AC-26-13

[SP-2026-00067](#) (Appeal)
SIGN-2025-00306 (Building Safety – Sign Permit)

MEMO

Subject: AC-26-13, SIGN-2025-00306: Lindmark Companies ("Applicant") appeals the Planning staff's decision to DENY a sign permit for a billboard conversion to a digital billboard for the property located at 3107 San Mateo Blvd NE, zoned MX-M.

Address/Location of sign to be removed: 3107 SAN MATEO BLVD NE

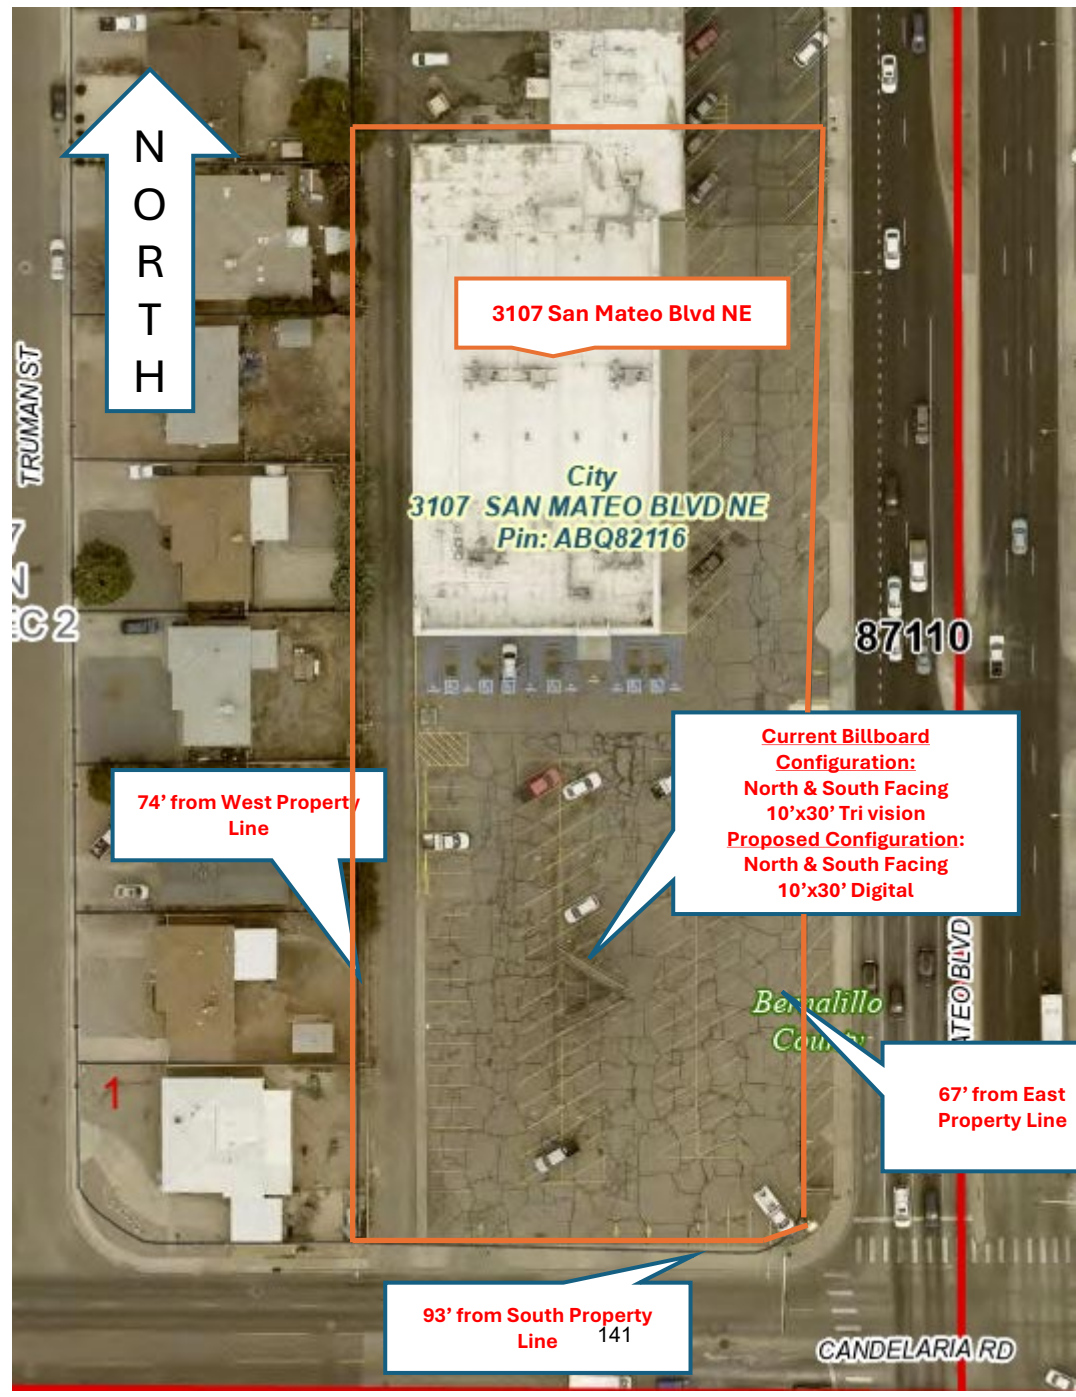
Zoning - General Note: This application for a conversion to a digital electronic sign cannot be approved by Zoning until you provide sufficient evidence of three separate billboard signs that will be permanently removed at different locations, as per IDO 5-12(H)(3)(b)(2). JPalmer

Lindmark Companies
Digital Conversion
3107 San Mateo Blvd NE
10'x30' Tri-vision Three (3) faces
James Spence
940.867.1467

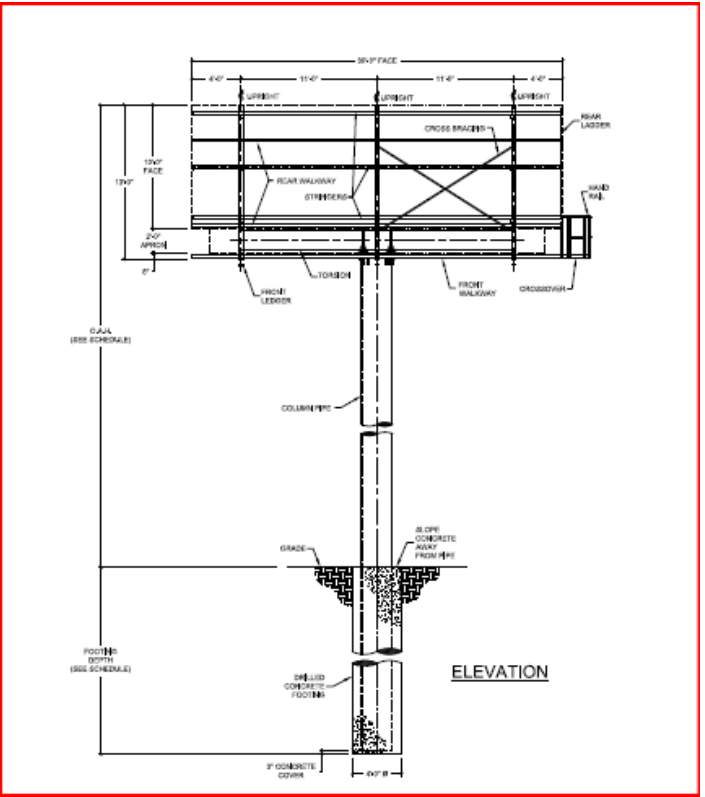
Zoning - Cap and Replace Off-Premise Sign Removal Application is incorrect in citing the existing sign in the same location towards the removal credit. For a sign to be counted as "removed advertising space," it must be removed and not replaced, as per IDO 5-12(H)(3)(b)(4). Both the sign and its support structure must be permanently removed, as per IDO 5-12(H)(3)(b)(2). JPalmer
